Work Order ID 99737

Item Name: Crosstube Fwd High

DART AEROSPACE LTD		Work Order:	99737
Description: Crosstube High Fwd (205/212/412)		Part Number:	D212-664-101
Inspection Dwg: D212-664-141 Rev: D		Page 1 of 1

DRAWING NO. D212-664-141	TITLE XTUBE ASSY (205/212/412 HI FWD)	REV. D	DART AEROSPACE LTD ENGINEERING ORDER		D.E.O. NO. D212-664-141-D-1	SHEET NO. SHEET 1 OF 2	SCALE NTS
DRAWN	CHECKED	OP	MFG. APPR.	APPROVED	DE APPR.		
DATE 11.04.07	DATE 11.07.11		DATE 11.04.12	DATE 11/04/12	DATE 11.04.12

**D212-664-141/-141B
ASSEMBLY DETAIL**

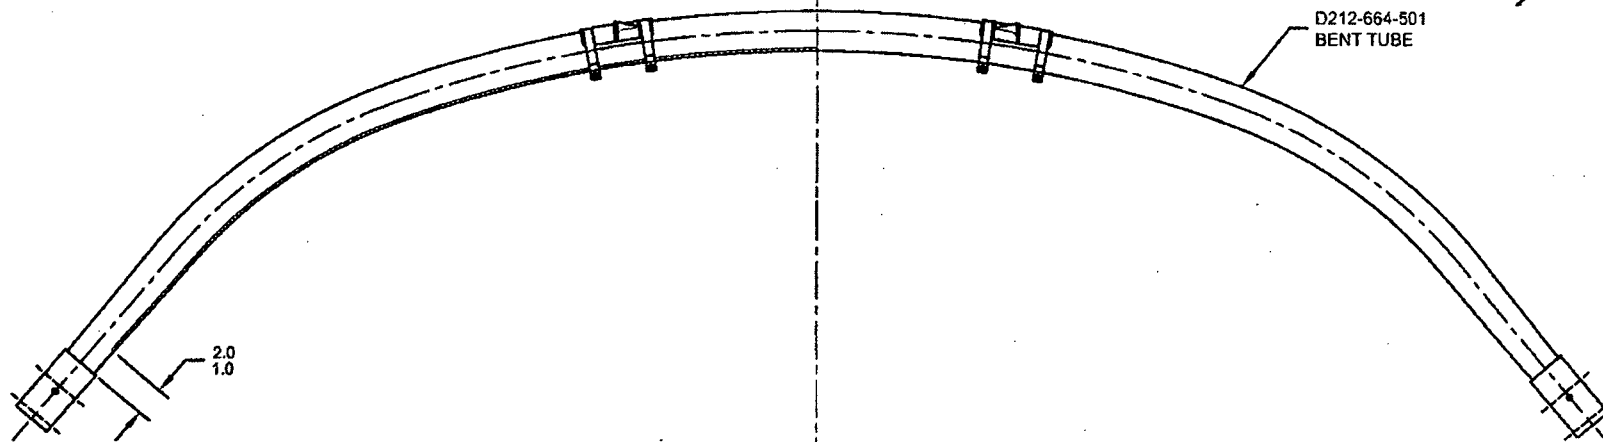
ADD AN INSPECTION WINDOW TO UNDERSIDE OF CROSSTUBE.

- 2) FINISH: CHEMICAL CONVERSION COAT PER DART QSI 005 4.1
PRIME INSIDE AND OUTSIDE PER DART QSI 005 4.2
MASK UNDERSIDE OF CROSSTUBE AS SHOWN (HATCHED AREA) AND
PAINT OUTSIDE PER DART QSI 005 4.2
REMOVE MASKING AND APPLY CLEAR COAT

- 2) FINISH: CHEMICAL CONVERSION COAT PER DART QSI 005 4.1
PRIME INSIDE AND OUTSIDE PER DART QSI 005 4.2
PAINT OUTSIDE PER DART QSI 005 4.2

MASK AREA PRIOR TO PAINTING,
REMOVE MASKING AFTER PAINT
AND APPLY CLEAR COAT
